Well Name: GB JACKSON TR6	Well Location: T17S / R30E / SEC 27 / TR 6 / NWNE / 32.8109733 / - 103.9575118	County or Parish/State: EDDY / NM
Well Number: 3	Type of Well: INJECTION - ENHANCED RECOVERY	Allottee or Tribe Name:
Lease Number: NMLC028992B	Unit or CA Name: GRAYBURG JACKSON	Unit or CA Number: NMNM70955X
US Well Number: 3001504356	Operator: SAGUARO PETROLEUM LLC

Sundry ID: 2787805

Type of Action: Plug and Abandonment

Procedure Description: Saguaro Petroleum respectfully requests a 90 day extension to the P&A of the Grayburg Jackson 003H. Please see attached wellbore and email with Long Vo.

Grayburg Jackson Unit 003A
30-015-04356
B-27-17s-30e
Eddy County, NM

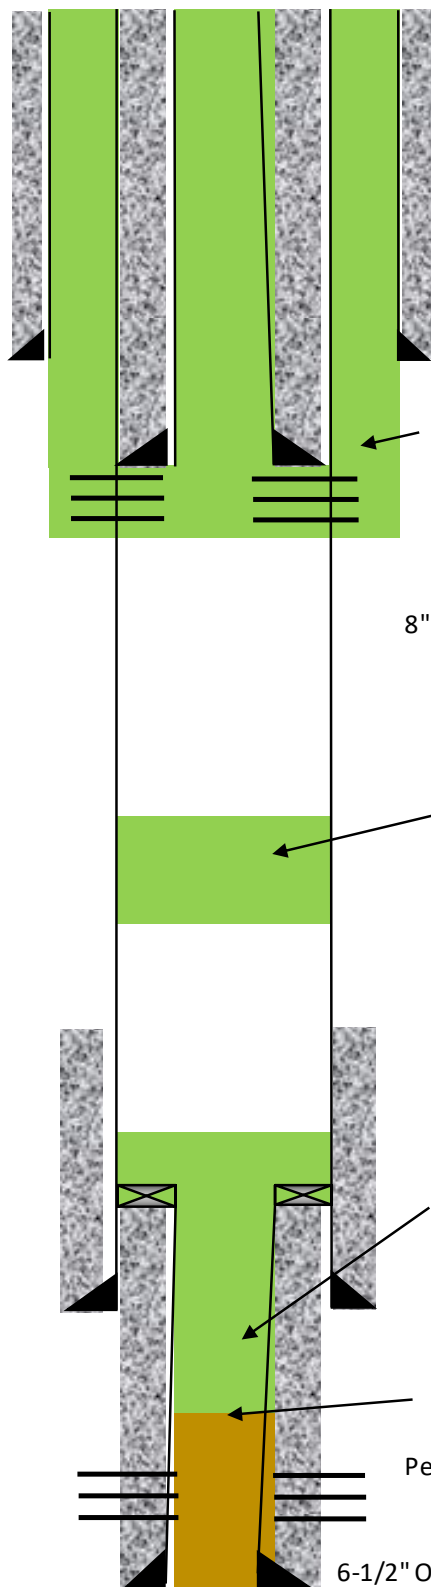
After reviewing the updated procedure, I do agree that further milling is unnecessary. However, the amount of cement and placement of the cement plugs will need to be adjusted to meet BLM requirements.

1. Please pump at least 151 sacks class C below the CICR at 2263' and spot 25 sacks on top of the CICR instead of 15 sacks. Please WOC for 4 hours and Tag @ 2118'.
2. The next plug shall be perforated at 1495' and squeeze to 1158'. (58 sacks within the 7" casing and 21 sacks within the annular space), WOC for 4 hours and Tag at 1158'. (Yates @ 1445', Tansill/Base of Salt @ 1300')
3. The surface plug shall be perforated at 616', squeeze, and circulated to surface. (125 sacks within the 7" casing and 62 sacks within the annular space). Verify cement at surface across all casing strings. (Top of Salt @ 480', Liner Shoe @ 566', Surface casing shoe @ 450').
